IEEE P802.15
Wireless Personal Area Networks

Project	IEEE P802.15 Working Group for Wireless Personal Area Networks (WPANs)	
Title	FCSL/PAL - MAC/MLME SAP Proposal	
Date Submitted	[16, September 2004]	
Source	[John Sarallo] [Appairant Technologies] [150 Lucius Gordon Drive, West Henrietta, NY 14586]	Voice: [585-727-2014] Fax: [585-214-2461] E-mail: [sarallo@appairant.com]
Re:	[]	
Abstract	[This document contains a list or proposed changes to IEEE Std 802.15.3.]	
Purpose	[The purpose of this document is to propose changes to IEEE Std 802.15.3 to improve compatibility, performance and clarity in the standard.]	
Notice	This document has been prepared to assist the IEEE P802.15. It is offered as a basis for discussion and is not binding on the contributing individual(s) or organization(s). The material in this document is subject to change in form and content after further study. The contributor(s) reserve(s) the right to add, amend or withdraw material contained herein.

1. Introduction

Figure 91 - MSC showing the possible results of a primitive request

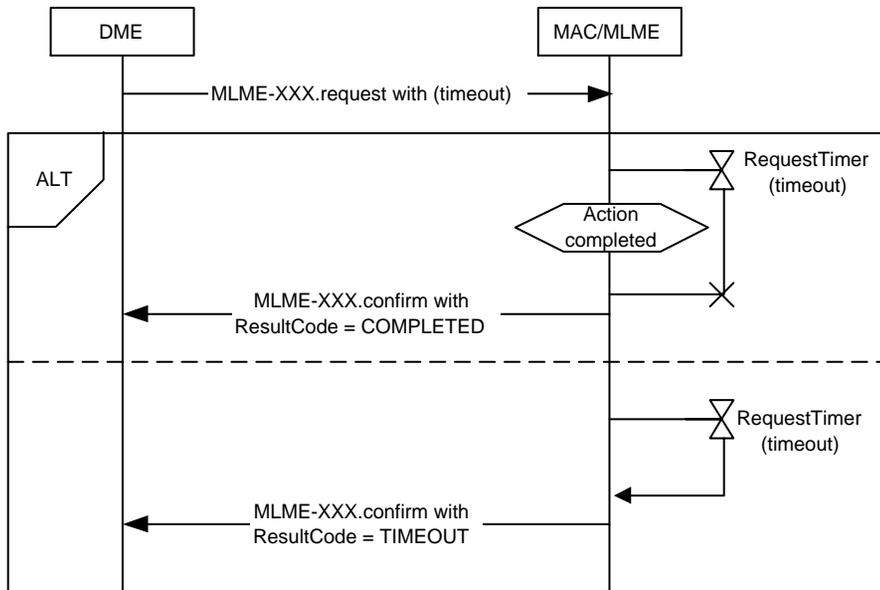
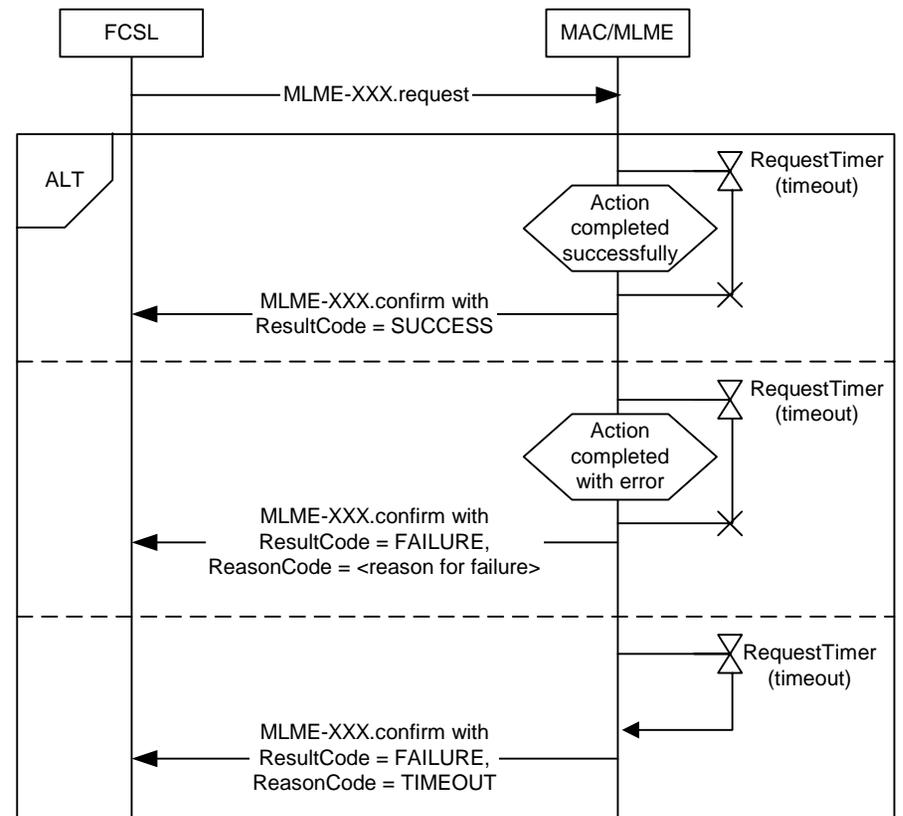
Suggested

Figure 125 - MSC of a DEV synchronizing with a PNC

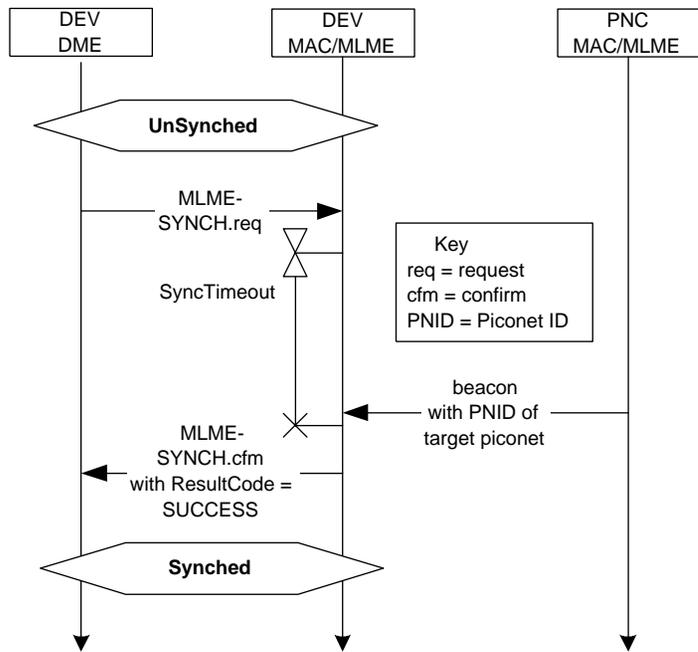
REMOVED

- Syncing now part of the association process.

Figure 102 - MSC of DEV-2 associating

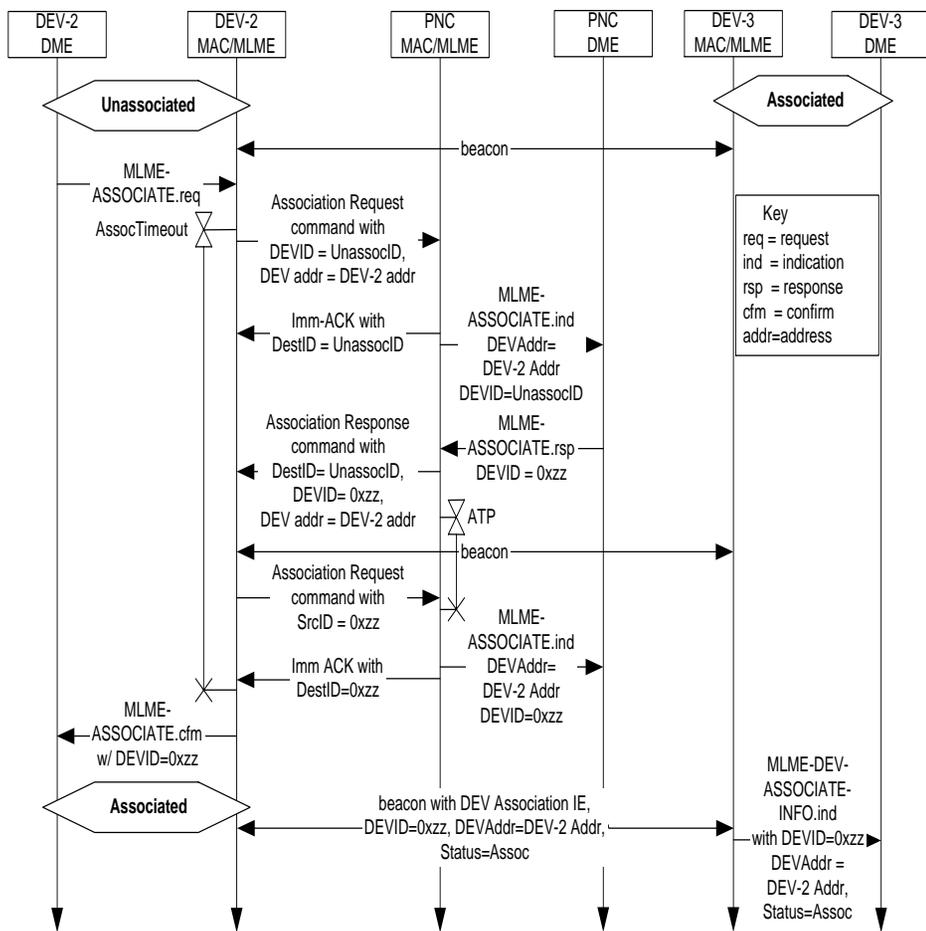
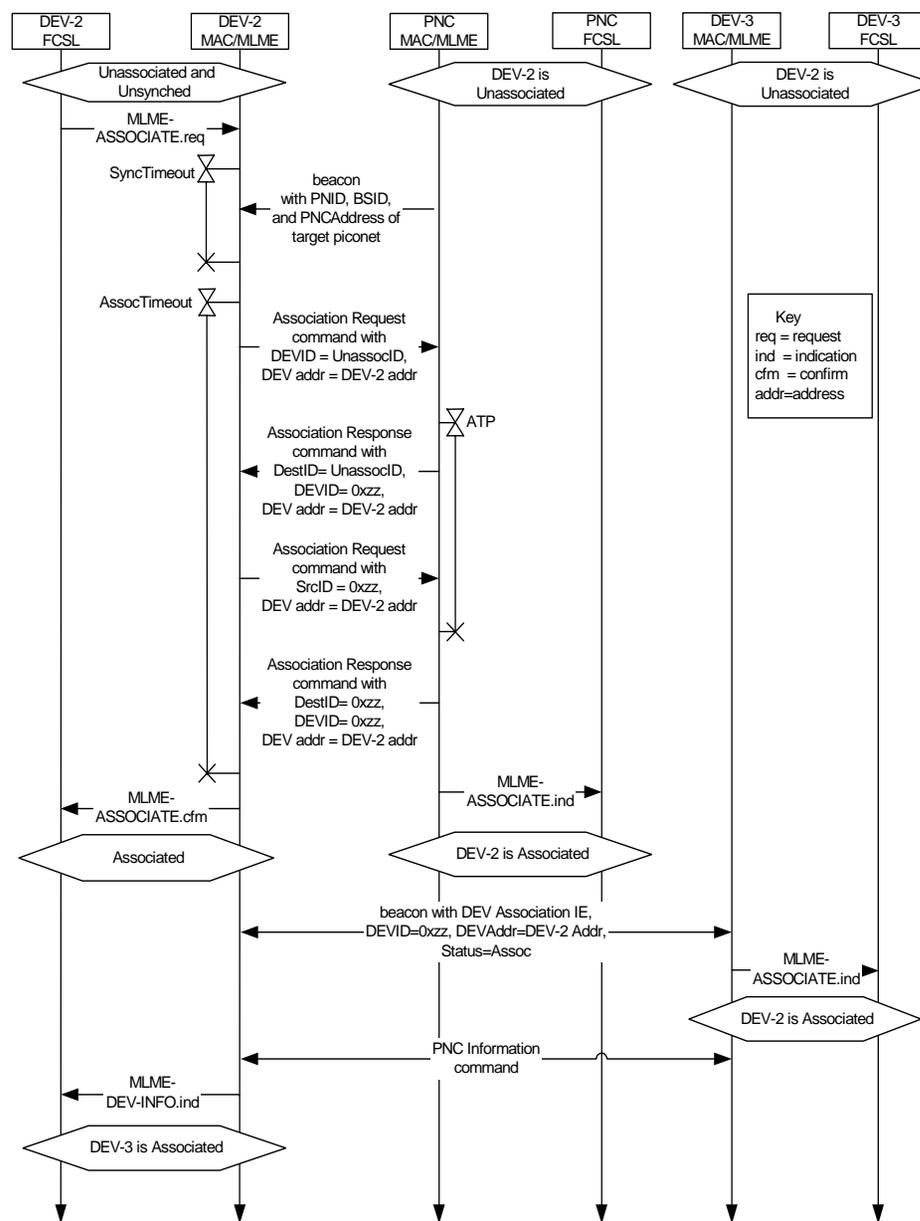
Suggested

Figure 120 - MSC of source DEV-2 requesting termination of its stream

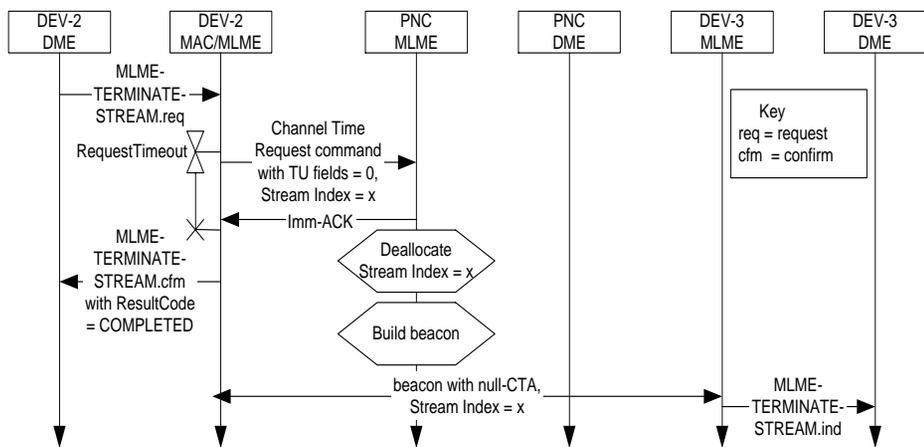
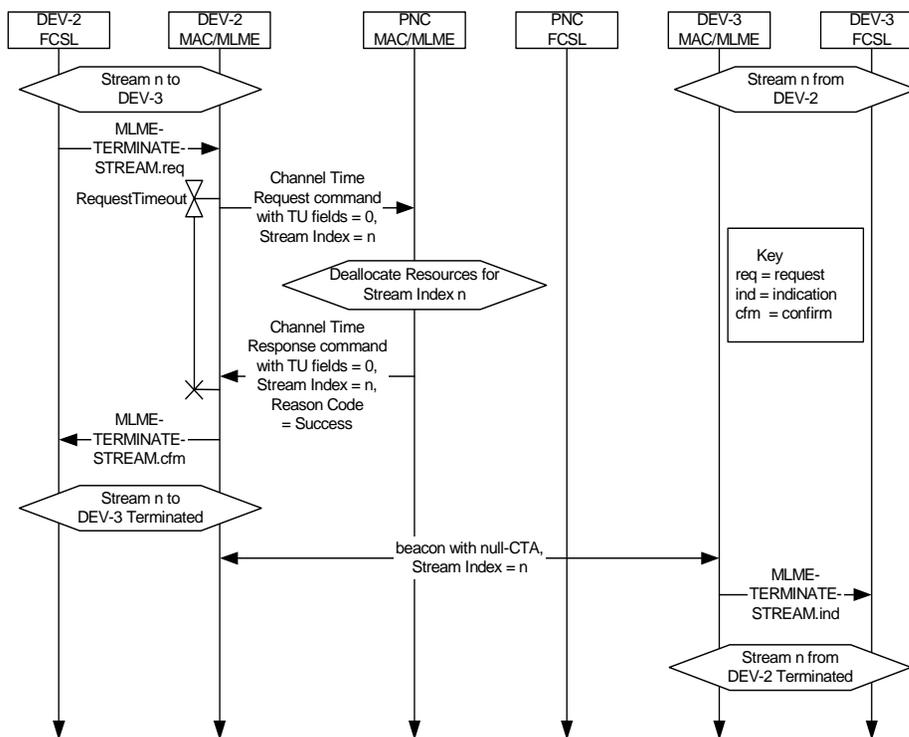
- Suggest defining NULL CTA such that a reason code for the stream termination can be provided to the Target DEV for the stream.

Figure 121 - MSC of target DEV-3 requesting termination of source DEV-2's stream

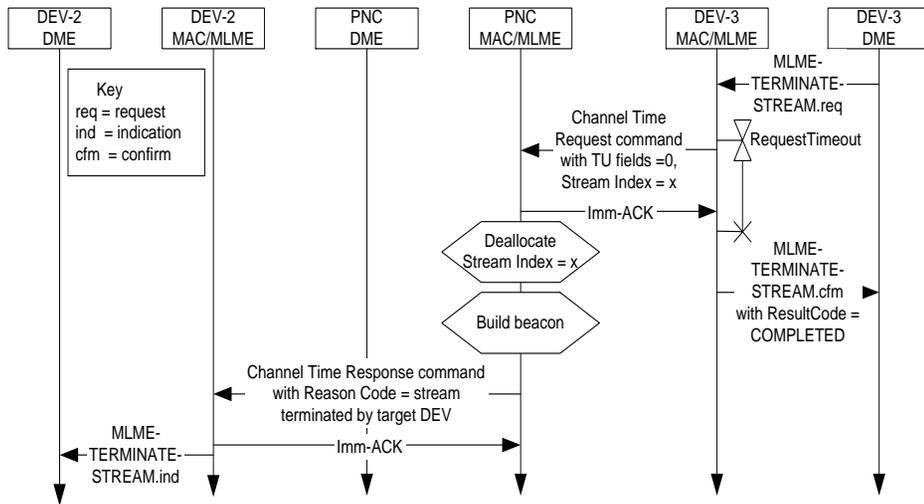
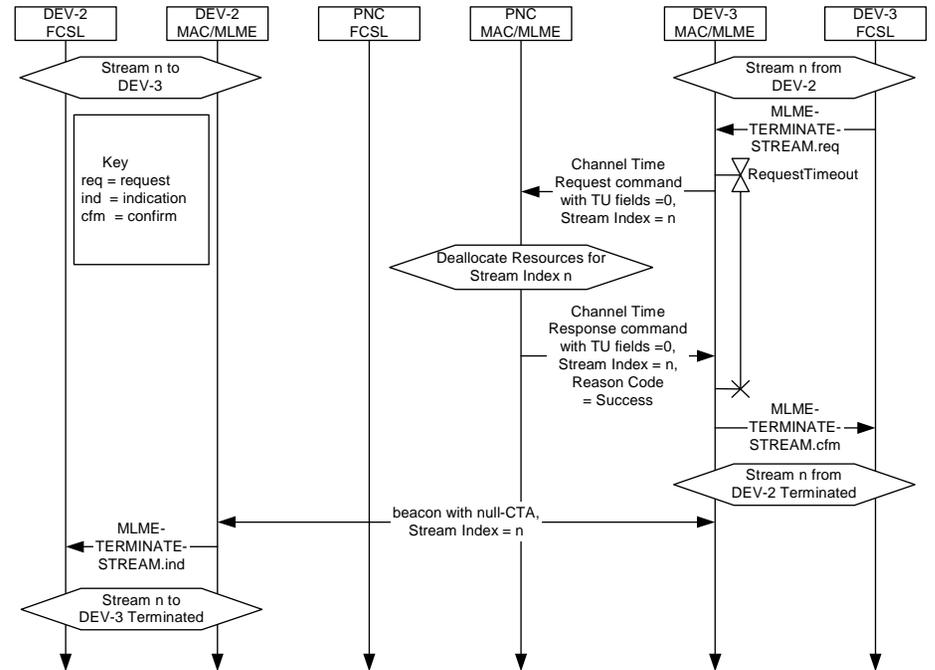
- Suggest defining NULL CTA such that a reason code for the stream termination can be provided to the Source DEV for the stream.

Figure 122 - MSC of PNC terminating a stream

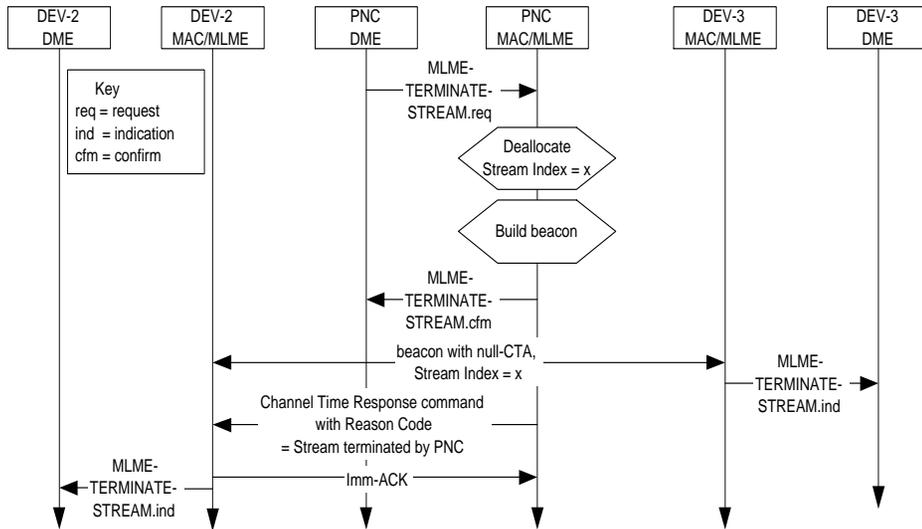
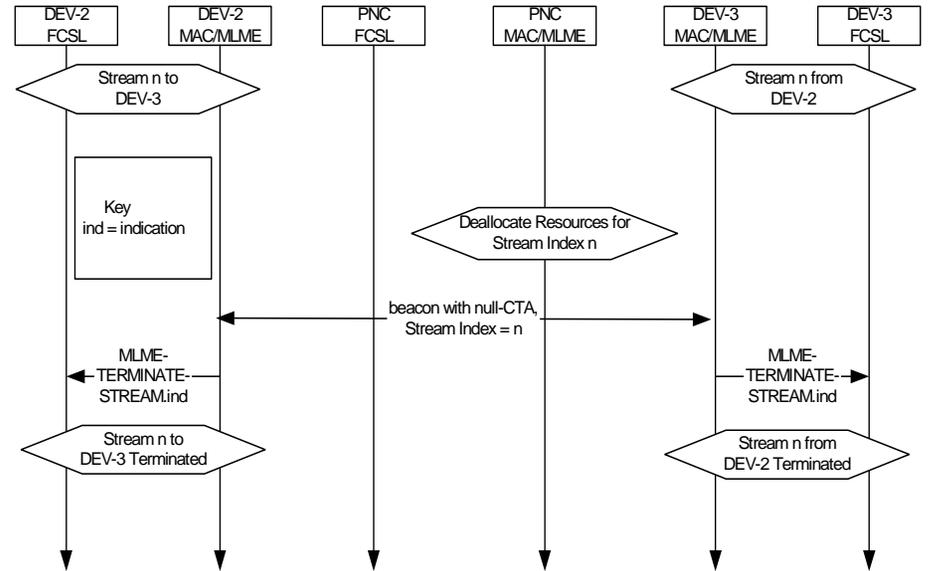
- Suggest defining NULL CTA such that a reason code for the stream termination can be provided to both the Source and Target DEVs for the stream.

Figure 130 - MSC for determining the channel status between two DEVs using the Channel Status Request and Channel Status Response commands

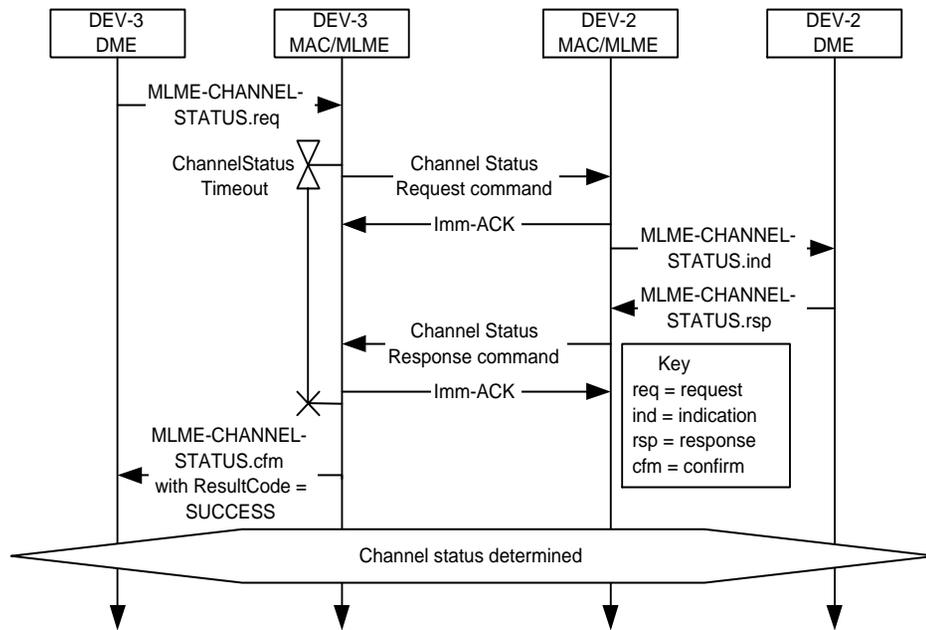
REMOVED

Figure 131 - Remote scan MSC

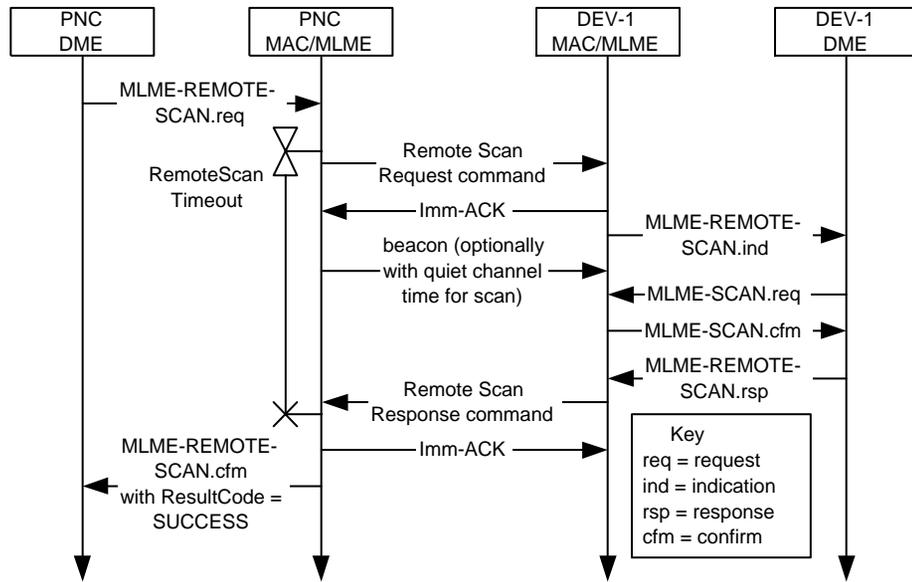
REMOVED

Figure 136 - Transmit power change MSC

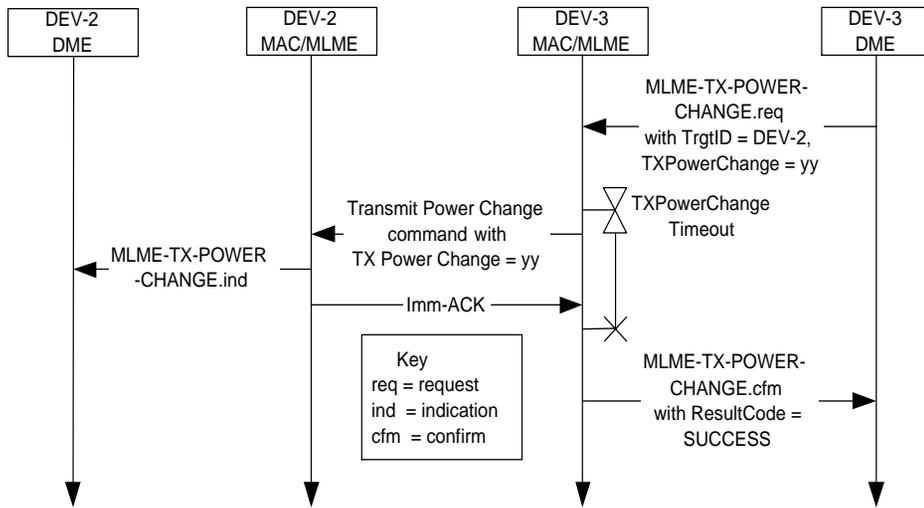
REMOVED

Figure 147 - Message sequence showing MLME initiated PM mode change from DSPS to ACTIVE in response to a new channel time allocation

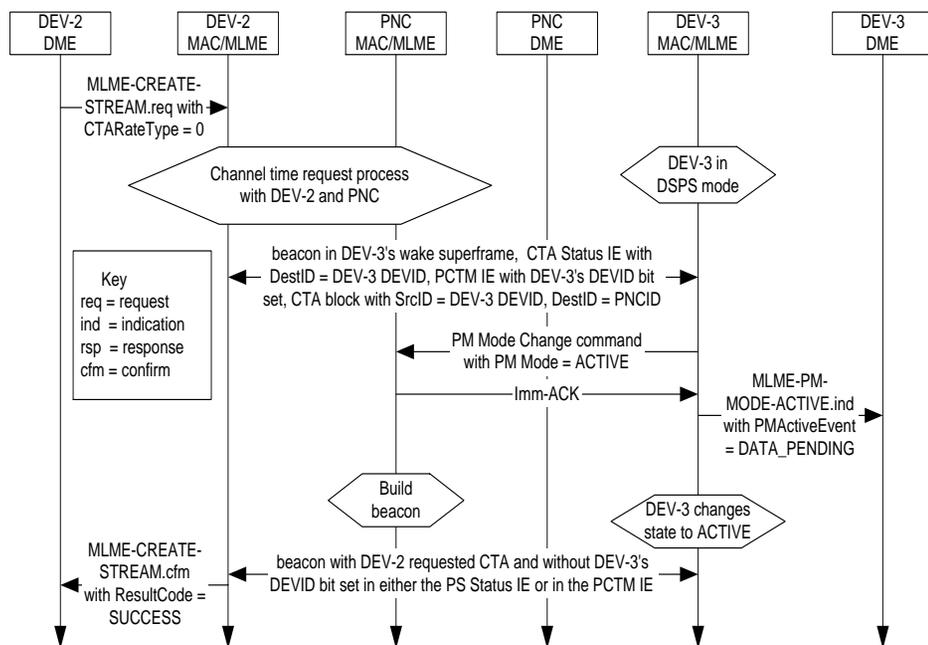
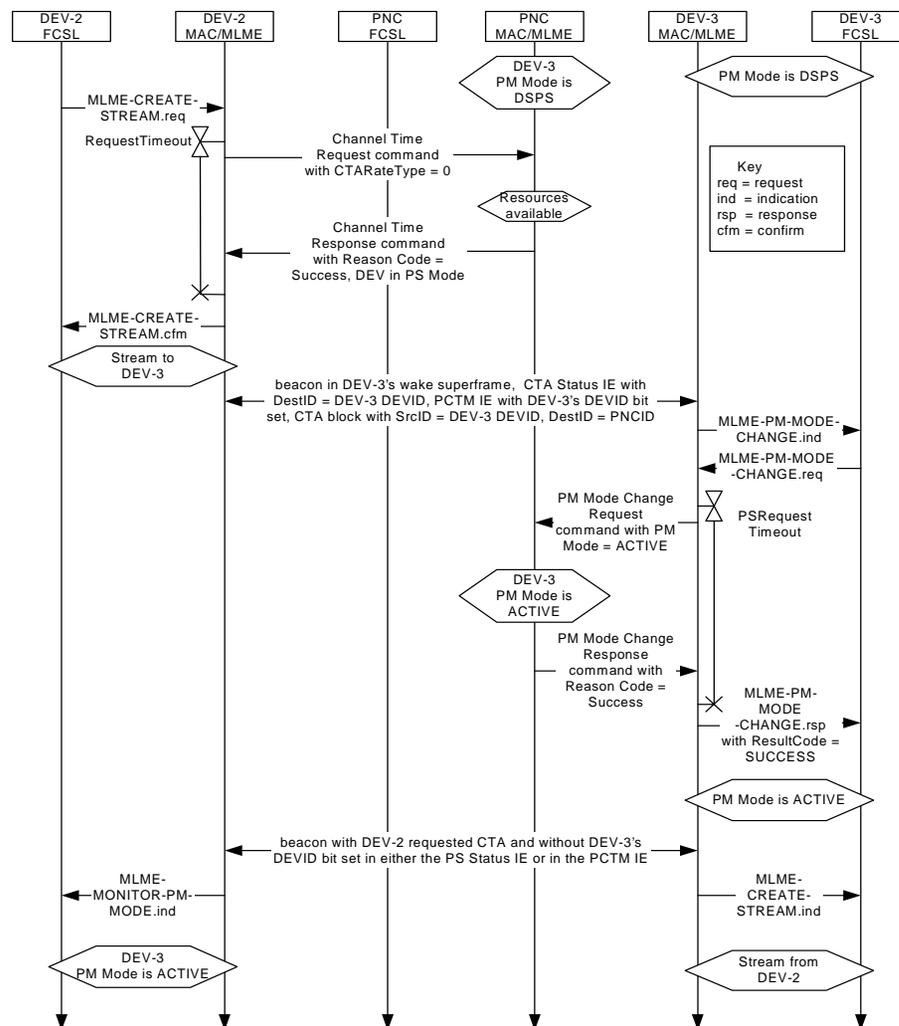
- Suggest monitoring of target DEV PS Mode be automatically activated in channel time request is received for a PS DEV.

Figure 152—Message sequence chart for peer-to-peer key distribution

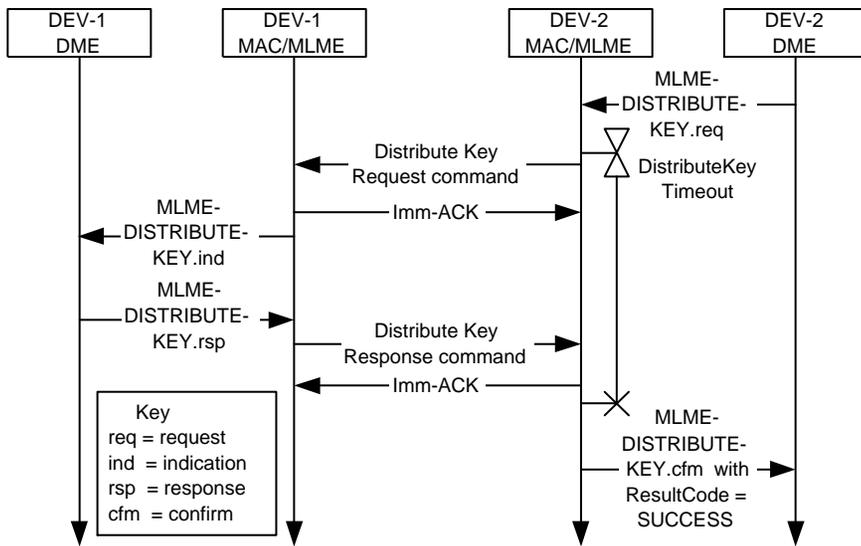
REMOVED

Figure 153—Message sequence chart for DEV key request

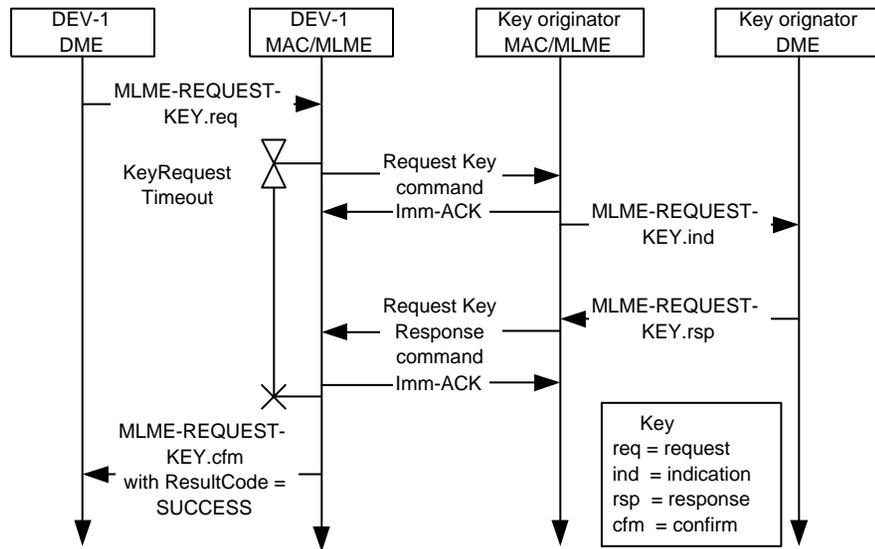
REMOVED
